SUBJECT: Engineering Practice Study to Review the Dimensions of the UA Case  
Outline.  
Project Number 5961-2011-089

ENGINEERING PRACTICES STUDY

TITLE: REVIEW THE DIMENSIONS OF THE UA CASE OUTLINE DIMENSIONS

FIGURE X. Physical dimensions, surface mount (UA version).

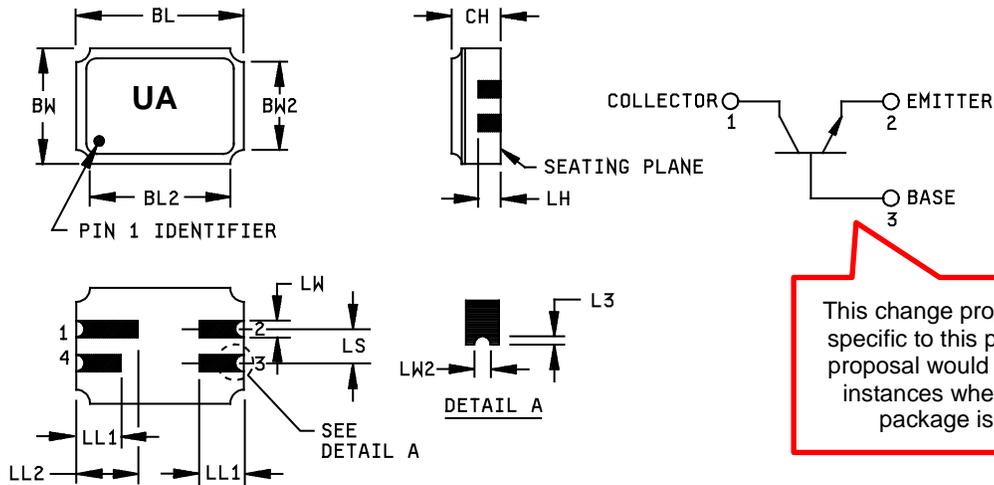
II. **BACKGROUND:** While performing lot acceptance testing of a UA package, an error in the package dimension requirements was found. The error is with the L3 dimension limits of .003 inch min to .007 inch max on all UA case outlines found in MIL-PRF-19500 specification sheets. A manufacturer of these packages defines the L3 dimension as .004 inches minimum with no maximum dimension limit. Actual parts are measuring in the range of .012 through .013 inches, which is non-compliant to the previously stated L3 dimension requirement. When introducing new case outlines to MIL-PRF-19500 specification sheets, only dimensions specified by the case manufacturer are used. It is unknown if the first original case outline submitted for inclusion in MIL-PRF-19500 specification sheets contained both minimum and maximum dimensions, or only minimum dimensions. Currently all UA case outlines specify both minimum and maximum L3 dimensions.

It has been proposed that the maximum limit for the UA L3 dimension be removed and only require a minimum limit of .003 inches.

See attachment 1 for the proposal to modify the UA case outline.

Symbol	Dimensions				Note
	Inches		Millimeters		
	Min	Max	Min	Max	
BL	.215	.225	5.46	5.72	
BL2		.225		5.72	
BW	.145	.155	3.68	3.93	
BW2		.155		3.94	
CH	.061	.075	1.55	1.91	3
L3	.003	<del>.007</del>	0.08	<del>0.18</del>	5
LH	.029	.042	0.74	1.07	
LL1	.032	.048	0.81	1.22	
LL2	.072	.088	1.83	2.24	
LS	.045	.055	1.14	1.40	
LW	.022	.028	0.56	0.71	
LW2	.006	.022	0.15	0.56	5

FIGURE 2009-2. Castellation requirements

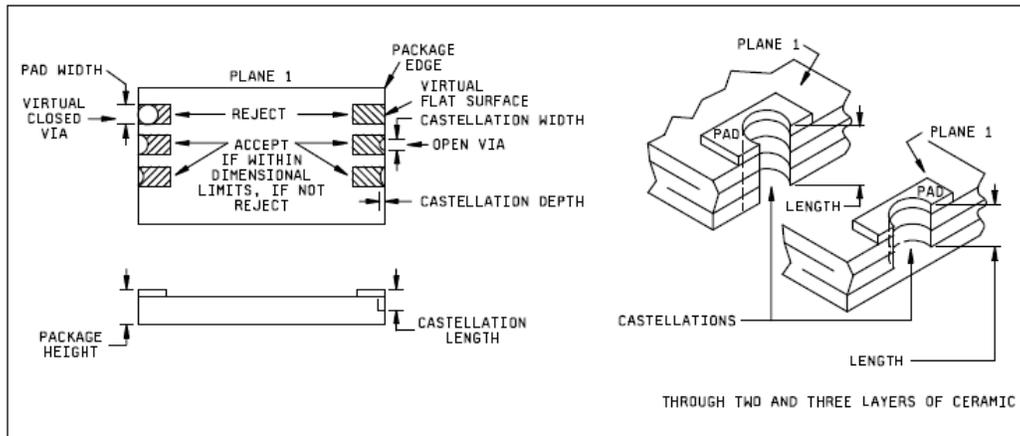
In addition, another proposal received was to utilize the castellation guidelines already in place in the MIL-STD-883 TM2009. This would ensure that with some reasonableness the castellations are not viewed as virtual flat surfaces on the package edge and are not virtual closed vias (holes). Using this requirement would require MIL-STD-750 to be updated with this portion of the external visual test method for castellations.

See attachment 2 for the castellation section of TM2009 of MIL-STD-883.

- d. Castellation configuration not in accordance with the following (see figure 2009-2). The castellation shall be roughly concave, confined by a 3-dimensional space traversing all castellated ceramic layers at the package edge. The surface of the castellation may be irregular. The "3-dimensional space" has these dimensions:
1. Minimum width  $> 1/3$  package terminal pad width.
  2. Minimum depth  $> 1/2$  castellation minimum width.
  3. Length = as designed (see figure 2009-2).
  4. Maximum width  $\leq$  package terminal pad width.
  5. Maximum depth  $\leq 1/2$  castellation maximum width.
